THE NATIONAL ACADEMIES

Critique of the Sargent & Lundy Assessment of Cost and Performance Forecasts for Concentrating Solar Power

This letter report is the result of a brief but intensive study by the National Research Council (NRC) Committee for the Review of a Technology Assessment of Solar Power Energy Systems. Prepared for the U.S. Department of Energy's (DOE) Office of Energy Efficiency and Renewable Energy (EE&RE), this report critiques an assessment by Sargent & Lundy LLC (S&L), also contracted by the DOE, of the cost and performance forecasts for parabolic trough and power tower concentrating solar power (CSP) technology.¹ The NRC committee reviewed several drafts of the S&L document; however, this letter report is based mainly on Draft 3, which was delivered to the committee on October 12, 2002 [1]. The Executive Summary of that draft (SL-5641) is reproduced in Appendix A. Several post-October 12 revisions sent to the committee are also included in this analysis.²

Figure ES-1 -Levelized Energy Cost Summary

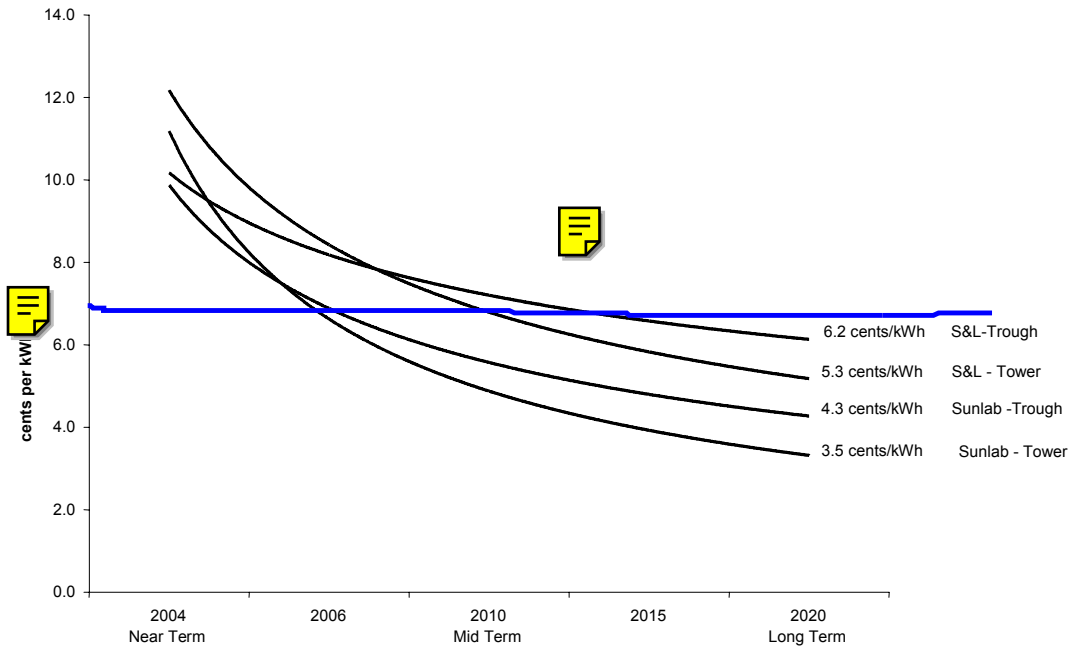
The S&L projection in Figure ES-1 in its report [1] shows CSP technology deployed with 100 MW each of trough and tower CSP capacity as being operational in 2004. Its report carefully notes, at the outset, the key assumptions for S&L’s assessment:

The committee believes that the S&L projection of a 100-MW plant being operational in calendar year 2004 is not credible on the basis of the information given in S&L's report [1]. Absent a statement that S&L has credible proprietary knowledge to the contrary, S&L's initial deployment projections should start later in time and the curve should shift to the right, further out in time. S&L's report and projection are deficient in this regard.

S&L is well aware of the long time and cost required for project execution starting with project formation, permitting, design, engineering, procurement, and execution through commissioning and operation. Even though S&L challenged and modified SunLab's assumptions on the time between deployments of new generations of technology, the committee believes that S&L's projection is still unrealistically optimistic.
